PHOTOGRAPHS

PHOTOGRAPH #23

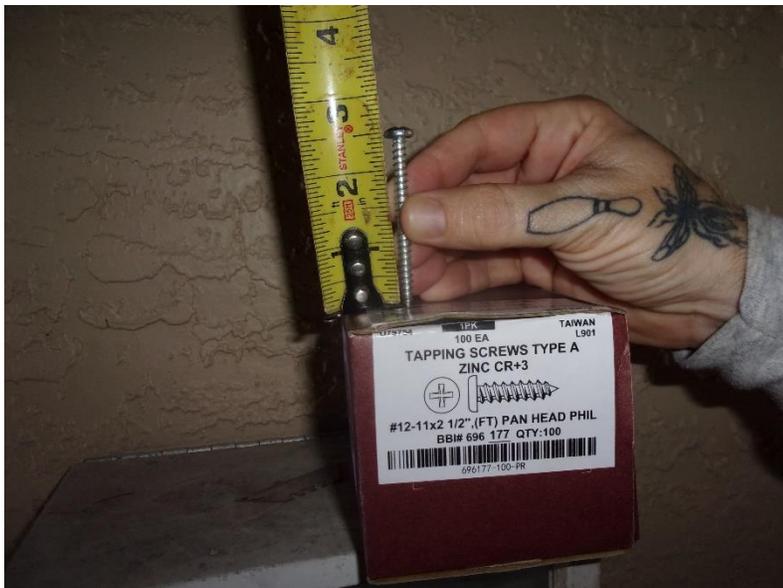
Contractor has made corrections at windows by applying #12 SMS screw at head location as per PGT Letter by Lynn Miller PE dated 9.17.2020. addressing the condition.
